Access Compliance Report

Public Rights-of-Way

(Curb Ramps)

Intersection ID: 12806	Main Street: E_STONEWALL_ST	Cross Street: S_COLLEGE_ST	Location: E
ADA ID: 9885C03A5396	Ramp Type: Perp	Initial Pass/Fail: Fail	Overall Compliance: No
Severity Score: 10			
Codes/Mitigation Info/Possible Solution		Field Measurements/Component Compliance

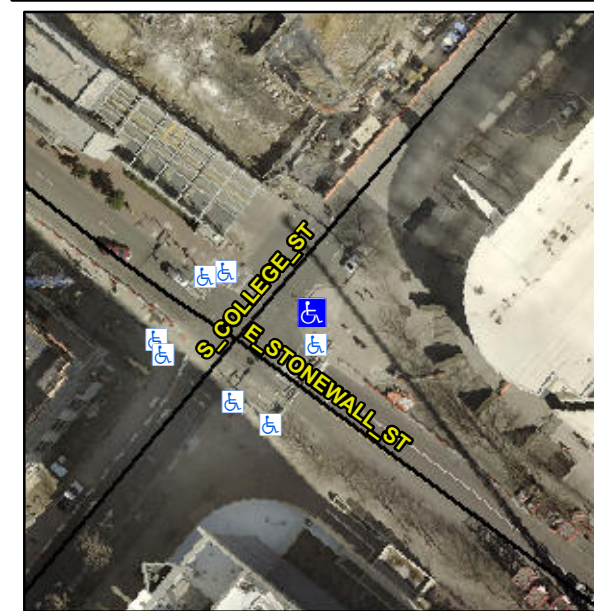
Not Found, R304.5.1, R304.5.3

Compliance	Description	Data	Compliance	Description	Data
N/A	Ramp Length (in)	73.0	Yes	Ramp Slope (%)	6.1
No	Ramp Width (in)	47.0	No	Ramp XSlope (%)	3.0
N/A	Flare Type LT	N/A	N/A	Flare Type RT	N/A
N/A	Flare Slope LT (%)	N/A	N/A	Flare Slope RT (%)	N/A
N/A	Flare Traversable LT?	N/A	N/A	Flare Traversable RT?	N/A
N/A	Landing Length (in)	N/A	N/A	DWS Provided?	N/A
N/A	Landing Width (in)	N/A	N/A	DWS Contrast?	N/A
N/A	Landing Slope (%)	N/A	N/A	DWS Length (in)	N/A
N/A	Landing X Slope (%)	N/A	N/A	DWS Full Width?	N/A
N/A	Landing Curb? (Y/N)	N/A	N/A	DWS Offset (in)	N/A
N/A	Shared Landing?	N/A			
N/A	Gutter Ponding?	N/A	N/A	Gutter Slope (%)	N/A
N/A	Gutter Lip Ht (in)	N/A	N/A	Gutter X Slope (%)	N/A
N/A	Painted X Walk1?	Yes	N/A	Painted X Walk2?	N/A
	X Walk 1 Direction	To NW		X Walk 2 Direction	N/A
N/A	X Walk 1 Width (in)	114.0	N/A	X Walk 2 Width (in)	N/A
	X Walk 1 Slope (%)	2.8		X Walk 2 Slope (%)	N/A
	X Walk 1 X Slope (%)	1.7		X Walk 2 X Slope (%)	N/A

Remove & Replace Entire Ramp.
